***RE: Comments on EPA DEIR/LRC Responsiveness Summary***

**Review by the General Electric  
Company of the USEPA Responsiveness  
Summaries: DEIR and LRCR**

**December 2000**

Figure 2-8. Comparison of the sediment and water column Log K<sub>oc</sub> values for PCB congeners used in USEPA's analysis of a combined pore water and bulk sediment loading source.

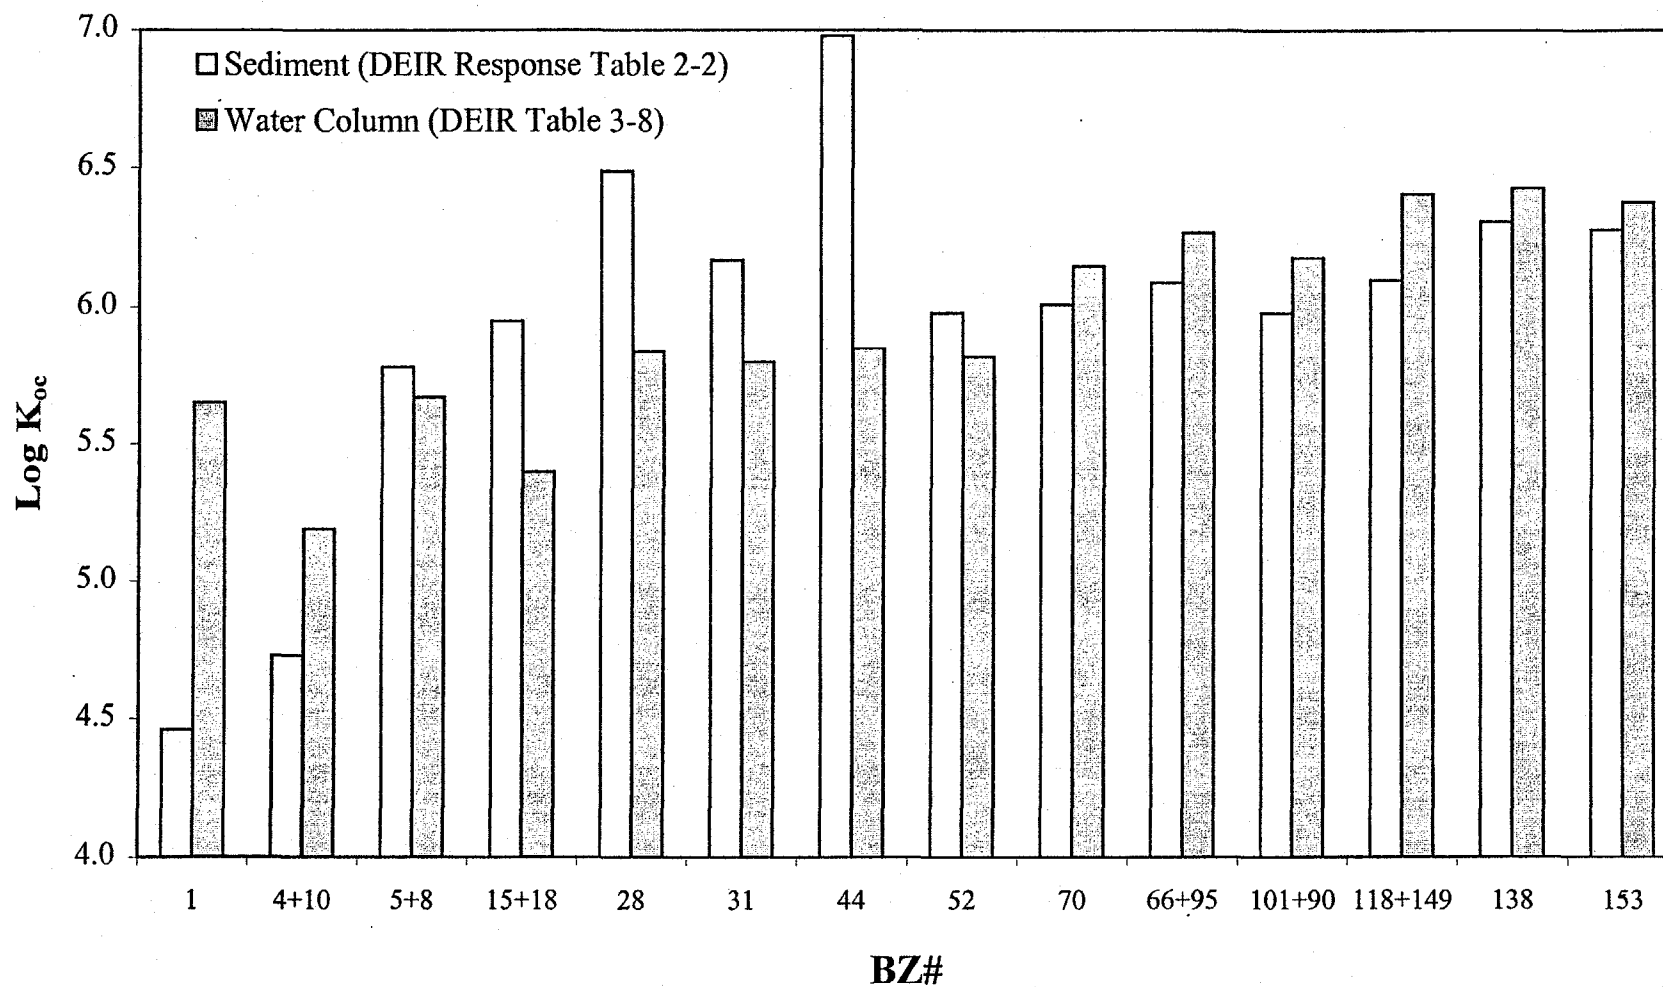
The main issue with USEPA's hypothesized sediment resuspension loading mechanism is that it invokes a large change in PCB partition coefficient when particles move from the bed to the water column (Figure 2-8). No scientific arguments are presented to rationalize why PCBs would alter their affinity for a particle simply because it has changed location. Indeed, such a change would be inconsistent with existing understanding of contaminant fate, and moreover, USEPA did not invoke such a change in its model (RBMR: page 106).

Figure 2-9. Spatial profile of average PCB loading from Fort Edward to Schuylerville for low flow data (<10,000 cfs) collected after 10/01/97.

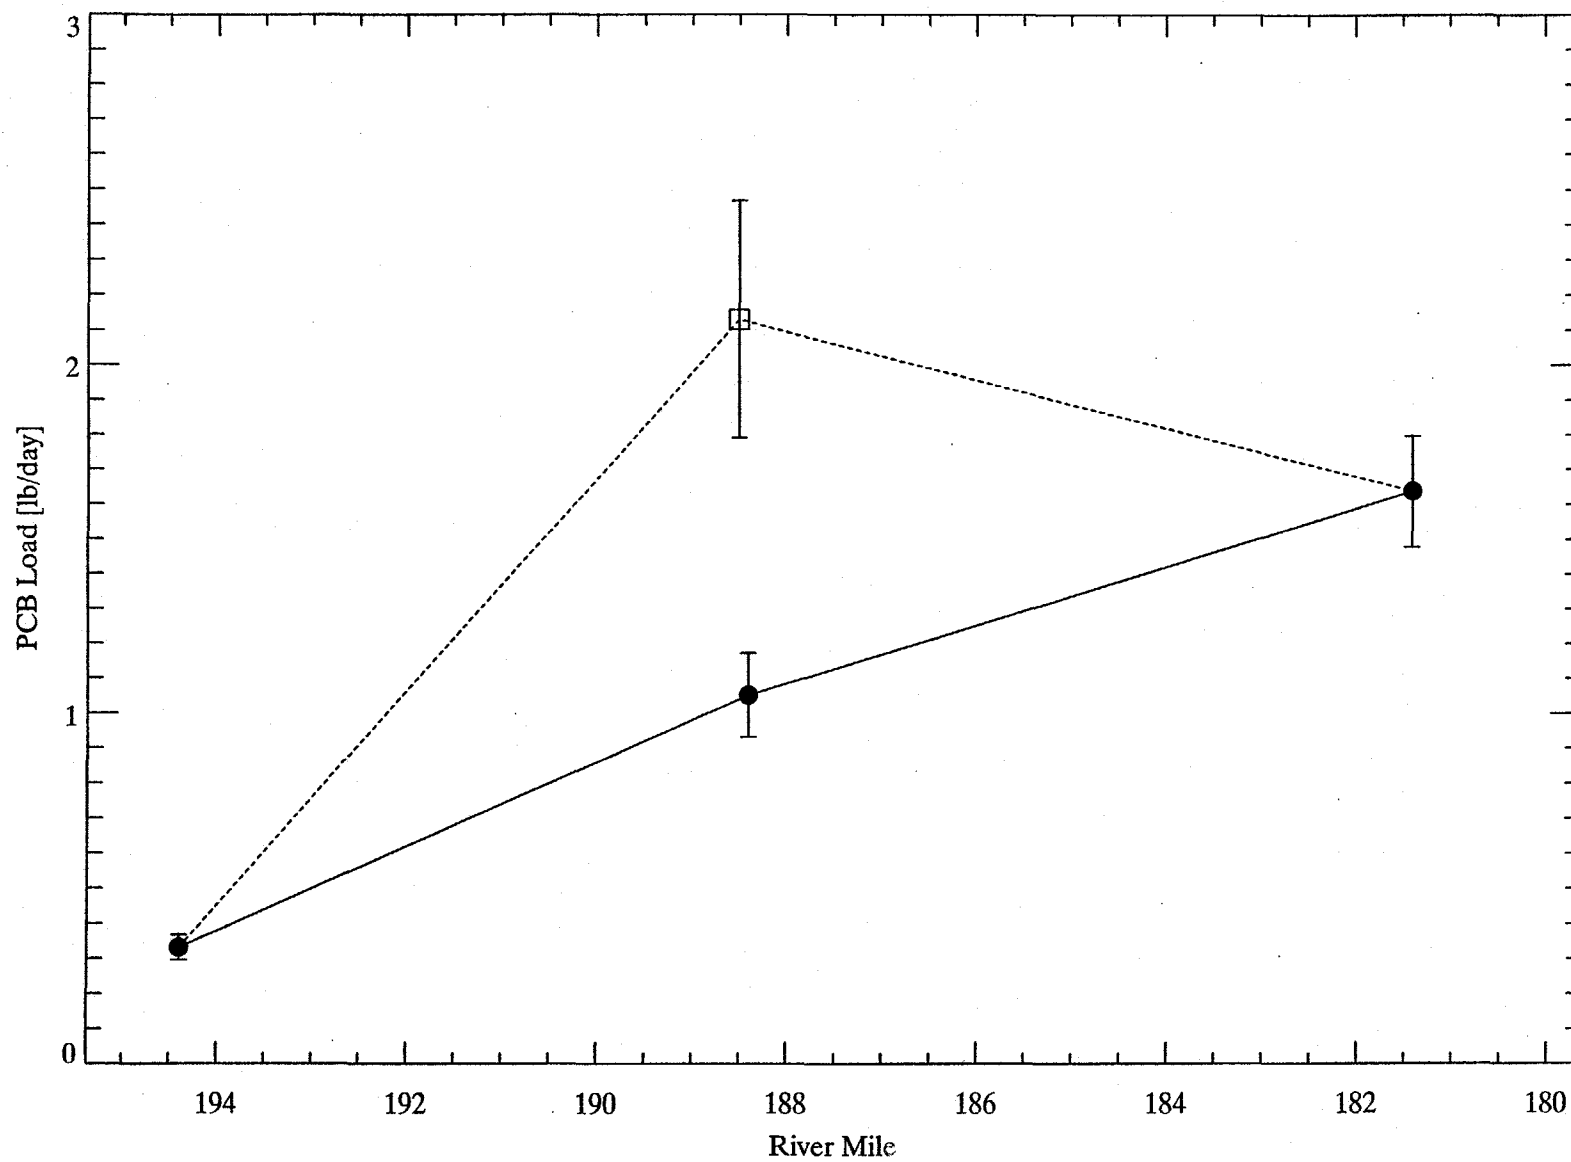
*Rebuttal:* The fate and transport mechanisms affecting PCBs are active in all reaches of the river, and should be incorporated equally in the mathematical models. There is no evidence that would indicate otherwise, and it would be highly unusual for it to be so. In fact, the water column data from the TI Dam and Schuylerville demonstrate that the processes operating in this reach are equivalent to those operating in the TIP (Figure 2-9).

Figure 4-1. Flow and PCB concentration at Fort Edward during high flow sampling conducted on March 28-30, 2000.

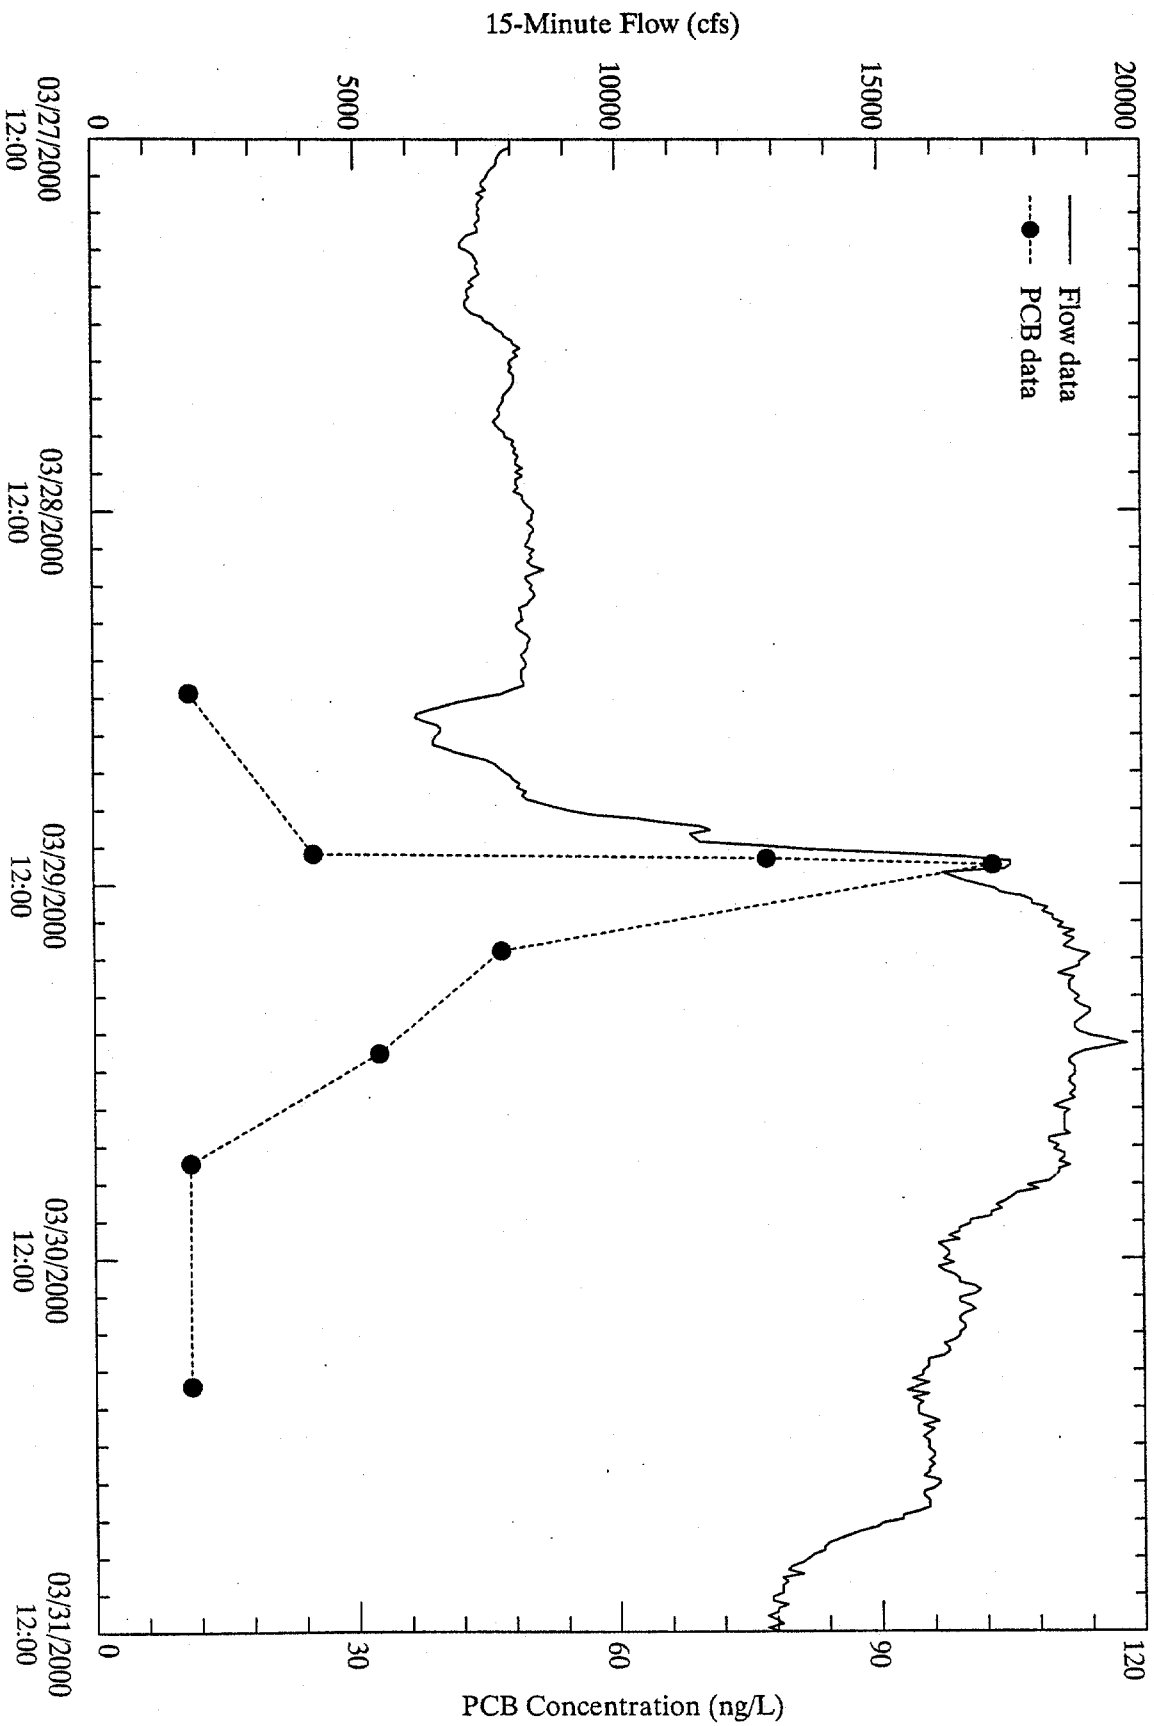
*Rebuttal:* USEPA missed GE's point that the peak PCB load at Rogers Island during high flow may not necessarily correspond to the peak flow, as the highest concentrations will be expected due to resuspension at the rising limb of the hydrograph. This point is exhibited by the March 2000 high flow sampling data conducted by GE, in which the highest PCB concentrations were observed prior to the peak flow (Figure 4-1).

Figure 5-2. Spatial profile of relative percent difference in MPA between 1984 sample pairs.  
 Number posted above plot panels indicate number of sample pairs in average.

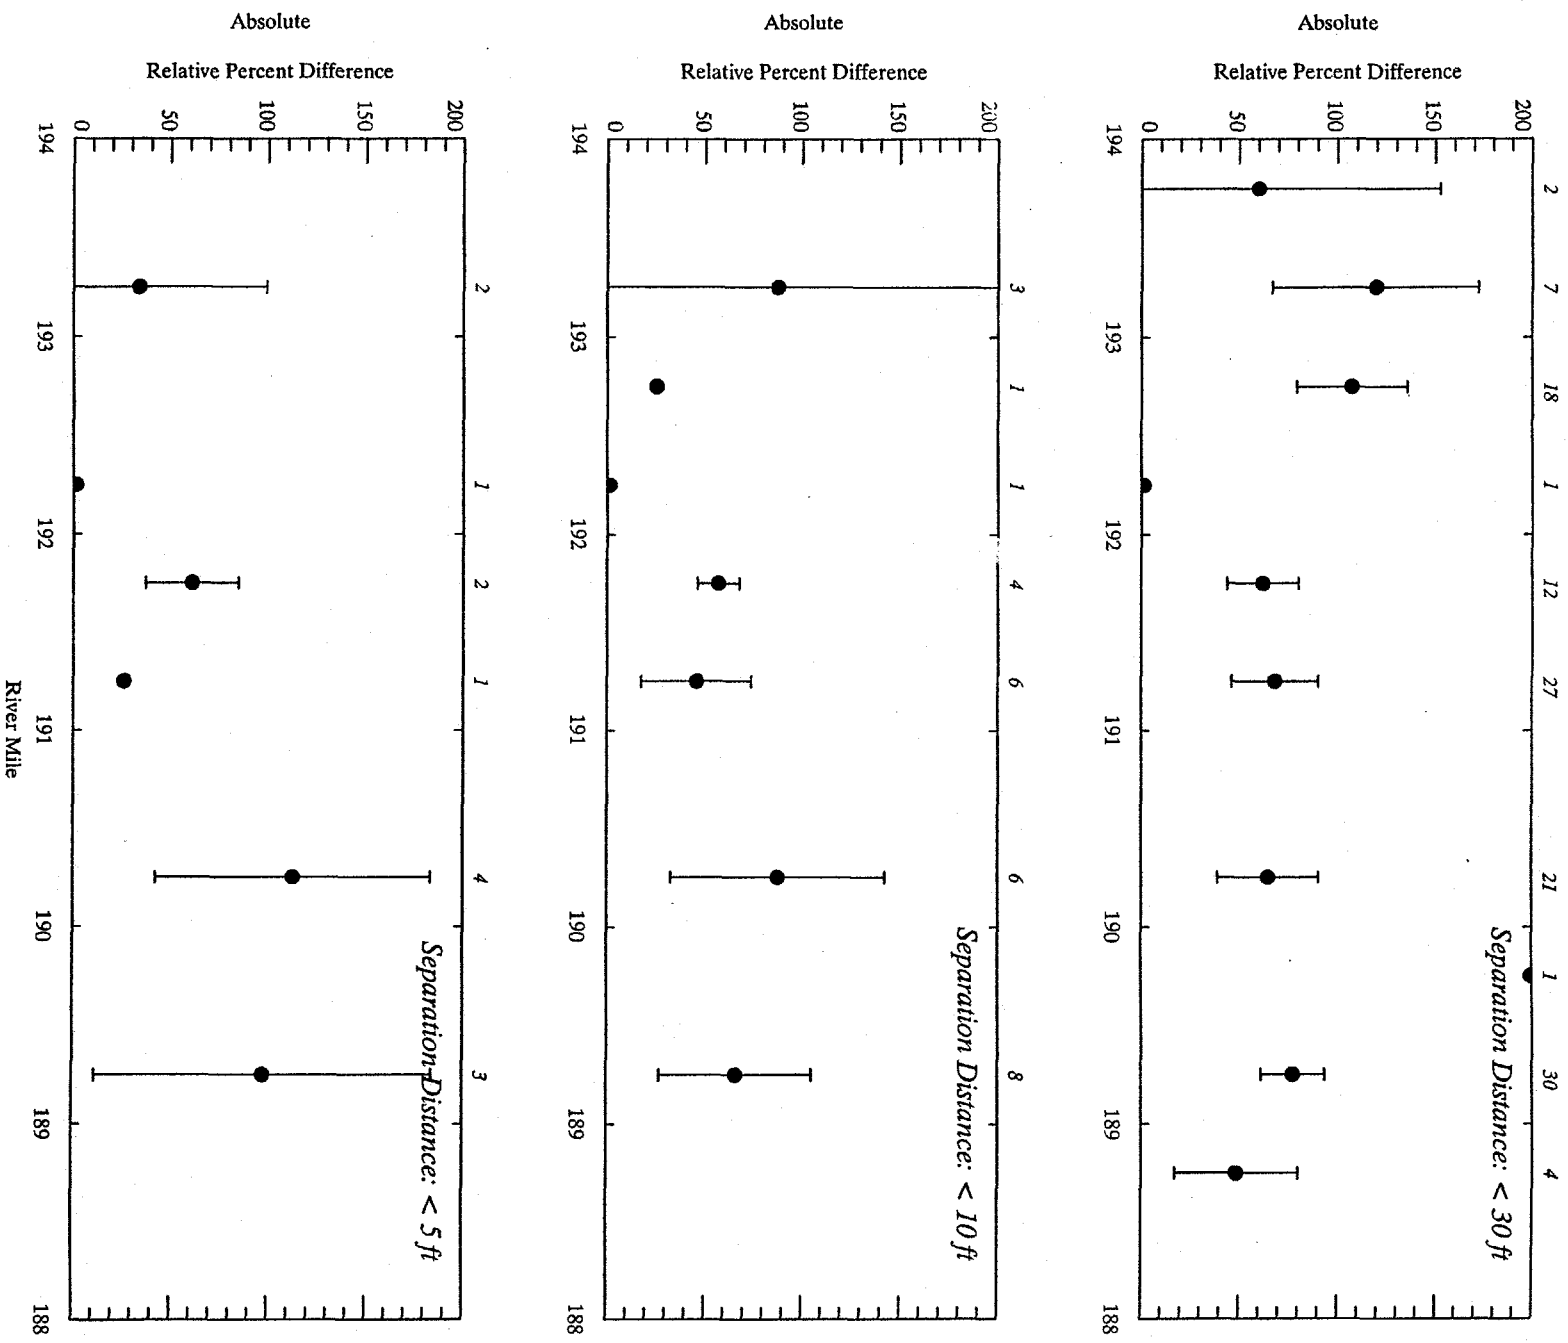
Thus, spatial bias exists within each "*cluster*," and, this spatial bias differs for the 1984 and 1994 samples. These spatial biases add significant uncertainty to the comparison of average PCB mass for 1984 and 1994 samples within these "*clusters*" because of the small-scale spatial variability in PCBs (e.g., Figure 5-2).

Figure 6-1. Locations of 1994 USEPA Low Resolutions Cores and 1984 NYSDEC sediment cores and grabs used for area based mass calculations in the LRCR Responsiveness Summary (Cluster LR-14).

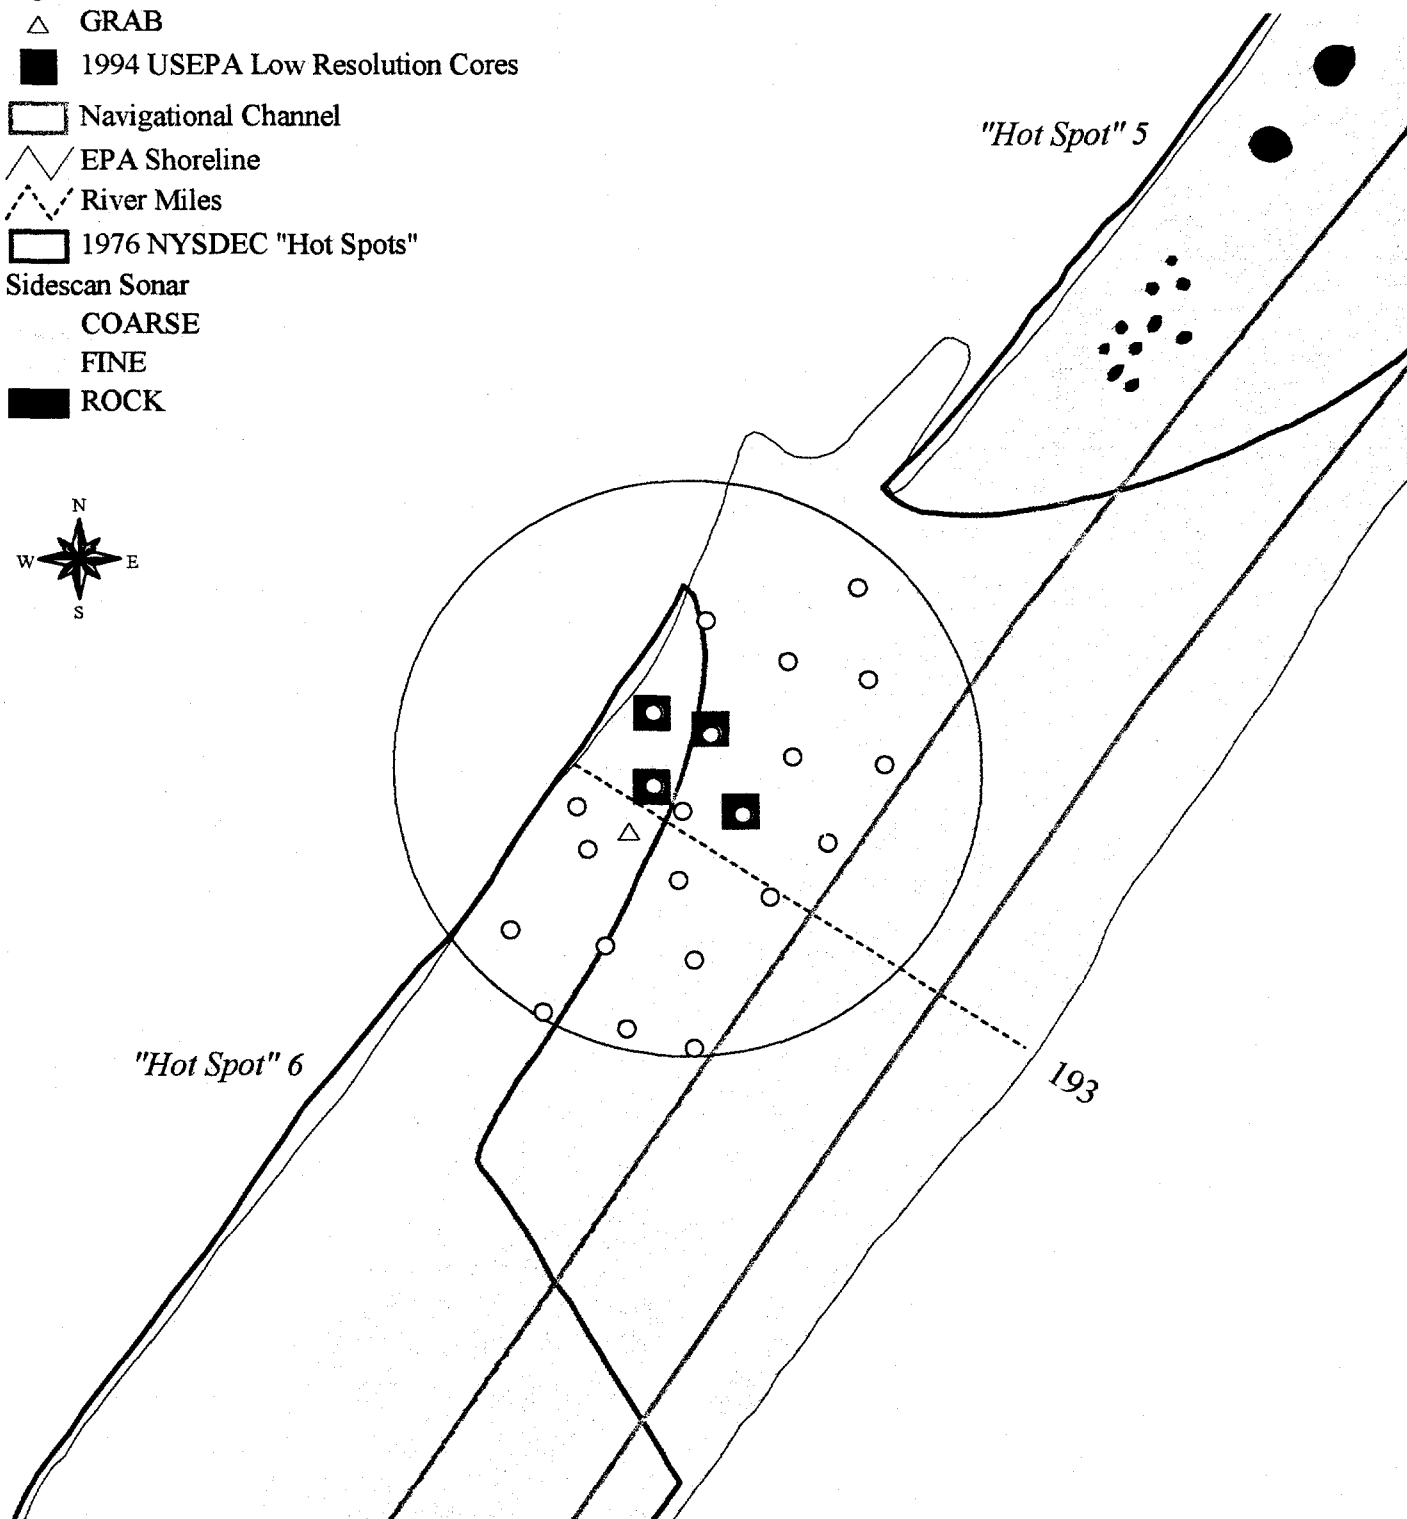
In the Agency's alternative ("*cluster*") analysis, sample data were used to represent a geographic area without any analysis of how well the data represent the area in which they are located. In fact, the data tend to be clustered rather than being randomly distributed within the areas; this is especially so for the 1994 data. This point is demonstrated by the sample locations for Cluster LR-14 shown in Figure 6-1. Although the 1984 samples are distributed throughout this particular "*cluster*," they span both fine and coarse sediments, and include locations both within and outside of "Hot Spot" 6. In contrast, the 1994 samples are more closely spaced together in this "*cluster*," and clearly do not represent the same sediment area as the 1984 samples (Figure 6-1).
